Addendum 1

City of Canton, Ohio

STA-Colonial Boulevard NE, Phase 1, PID 111059, GP 1206
Item/Project

GP1206 STA-Colonial Boulevard NE, Phase 1, PID 111059
Engineering Department

SPEED TABLE DETAIL

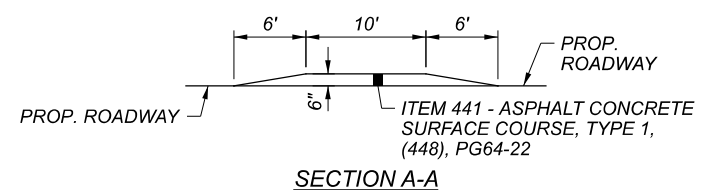
Sheet 10 – Changes to the Speed Table Detail to modify detail for Item 608 – Detectable Warning, As Per Plan.

△ DETAIL REVISED AND NOTE ADDED

ITEM 608 - DETECTABLE WARNING, AS PER PLAN

PAYMENT SHALL BE AT THE CONTRACT UNIT PRICE PER SQUARE FOOT FOR ITEM 608 DETECTABLE WARNING, AS PER PLAN INCLUDING ALL LABOR, MATERIALS, EQUIPMENT AND INCIDENTALS REQUIRED.

SHEET TOTAL
P.141 168

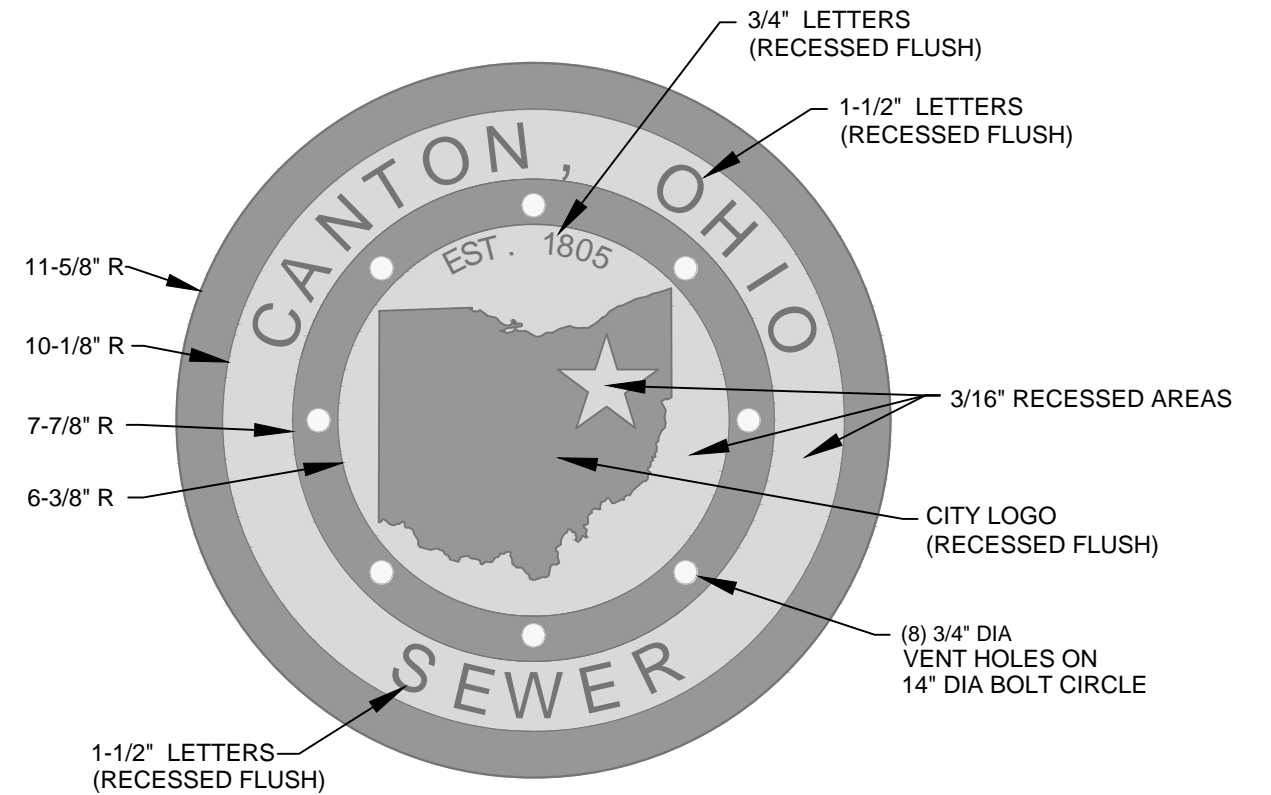
Sheet 141 – Modification made to Item 625 – Light Pole, Decorative, As Per Plan (Nostalgia) and note regarding pole painting removed. Poles shall be powder coated as per City SCD No. 63.

NOTE REVISED
